Project: Southview Farmhouse, Trowbridge

Subject: Response to LLFA Comments

Reference: 19682-TUM-TN-XXX-0001

Tumu Consulting Ltd has been appointed by Coulston Estates Ltd to provide a response to the Wiltshire Council Lead Local Flood Authority (LLFA) comments dated 17/04/2026 in relation to Planning Application Ref. PL/2026/01506 for the proposed development at Southview Farmhouse, Trowbridge.

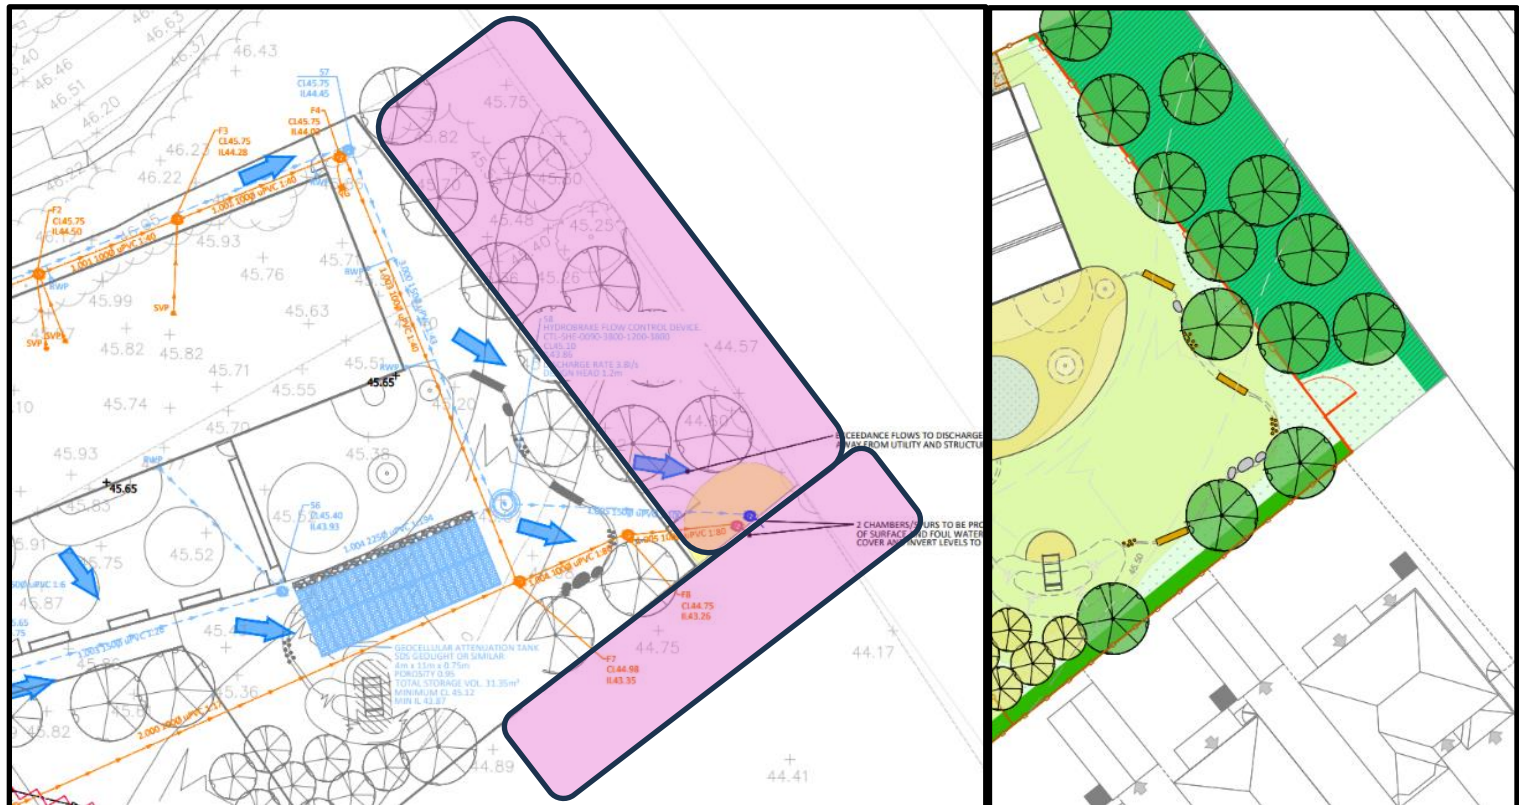
1. We note the applicant has stated in section 3.1 of the Drainage Strategy Statement that Redrow Housing have agreed to accept flows discharged at 3.8l/s. The applicant must provide a statement that demonstrates this agreement with Redrow Housing and acknowledges that any future drainage design and planning application on the Redrow Houses site will include a 3.8l/s discharge.
2. Post-development exceedance routing plans indicate that surface water exceedance flows are directed towards the future proposed development by Redrow Housing and the existing railway corridor.

The applicant is required to submit further details demonstrating how exceedance flows will be safely managed in the pink areas, demonstrating how exceedance will not increase flood risk to the future Redrow Housing development and the existing railway infrastructure. The LLFA would expect the applicant to manage flows onsite, without directing flows towards existing or proposed development.

2. Post-development exceedance routing plans indicate that surface water exceedance flows are directed towards the future proposed development by Redrow Housing and the existing railway corridor. The applicant is required to submit further details demonstrating how exceedance flows will be safely managed in the pink areas, demonstrating how exceedance will not increase flood risk to the future Redrow Housing development and the existing railway infrastructure. The LLFA would expect the applicant to manage flows onsite, without directing flows towards existing or proposed development.	An extract from the Wiltshire LLFA comments dated 17/04/2026 has been reproduced below. The areas highlighted in pink have been labelled Area 1 and Area 2 for ease of reference.  Area 1 comprises an existing soft-landscaped area that will be enhanced through the planting of additional trees. No alterations to existing ground levels are proposed within Area 1; therefore, existing surface water flow routes will remain unchanged and continue to be governed by the site's existing topography. Surface water runoff from Area 1 will continue to leave the site at greenfield runoff rates. As these flows reflect existing greenfield conditions, there will be no increase in flood risk to either the railway infrastructure or the proposed Barratt Redrow development. Area 2 lies outside the application site boundary and falls within the Barratt Redrow development site. As this area is outside our client's control and is proposed to be redeveloped as part of the Barratt Redrow scheme, responsibility for the management of surface water runoff within Area 2 rests with Barratt Redrow.
